Access Compliance Report

Public Rights-of-Way

(Curb Ramps)

Intersection ID: 51441	Main Street: TAMARRON_DR	Cross Street: WOODLAND_WATCH_CT	Location: E
ADA ID: 5BCA9B64C9E6	Ramp Type: BlendTrans1	Initial Pass/Fail: Fail	Overall Compliance: No
Severity Score: 1.25			
Codes/Mitigation Info/Possible Solution		Field Measurements/Component Compliance

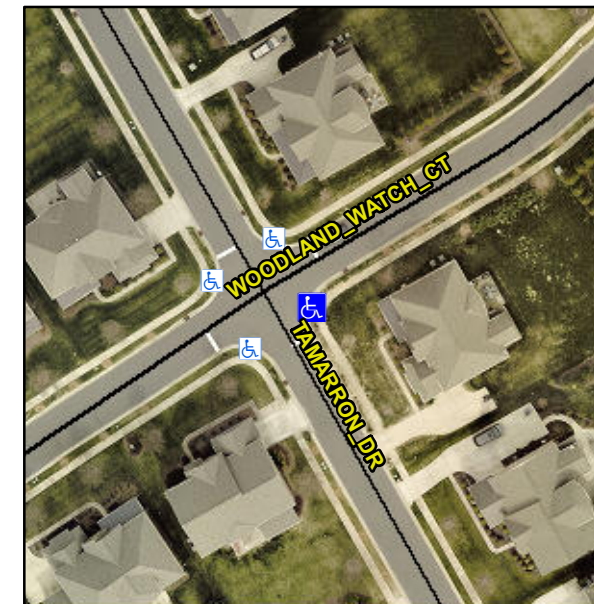
PROW/ADA:

Not Found, R304.5.3

Compliance	Description	Data	Compliance	Description	Data
N/A	Ramp Length (in)	47.0	Yes	BlendTrans Slope (%)	4.6
Yes	Ramp Width (in)	48.0	No	BlendTrans XSlope (%)	2.2
N/A	Flare Type LT	N/A	N/A	Flare Type RT	N/A
N/A	Flare Slope LT (%)	N/A	N/A	Flare Slope RT (%)	N/A
N/A	Flare Traversable LT?	N/A	N/A	Flare Traversable RT?	N/A
N/A	Landing Length (in)	N/A	N/A	DWS Provided?	N/A
N/A	Landing Width (in)	N/A	N/A	DWS Contrast?	N/A
N/A	Landing Slope (%)	N/A	N/A	DWS Length (in)	N/A
N/A	Landing X Slope (%)	N/A	N/A	DWS Full Width?	N/A
N/A	Landing Curb? (Y/N)	N/A	N/A	DWS Offset (in)	N/A
N/A	Shared Landing?	N/A			
N/A	Gutter Ponding?	N/A	N/A	Gutter Slope (%)	N/A
N/A	Gutter Lip Ht (in)	N/A	N/A	Gutter X Slope (%)	N/A
N/A	Painted X Walk1?	No	N/A	Painted X Walk2?	No
	X Walk 1 Direction	To NW		X Walk 2 Direction	To SW
	X Walk 1 Width (in)	N/A		X Walk 2 Width (in)	N/A
	X Walk 1 Slope (%)	2.5		X Walk 2 Slope (%)	3.5
	X Walk 1 X Slope (%)	1.3		X Walk 2 X Slope (%)	2.4

N/A	Ramp inside XWalk1?	N/A	N/A	Ramp inside XWalk2?	N/A
	Road Slope (%)	0.6		Clear Space?	N/A
	Road X Slope (%)	3.9	N/A	Clear Space to XWalk (in)	N/A
N/A	Any Obstructions?	N/A	N/A	Storm Grate/Utility Hazard?	N/A
	Obstruction Type			Storm Grate/Utility Type	
		N/A			N/A
			Yes	Surface Condition? (G/P)	Good
			No	Curb Slope (%)	17.4

Possible Solutions:

Remove & Replace Curb Ramp With Two New Directional Ramps or Equivalent.
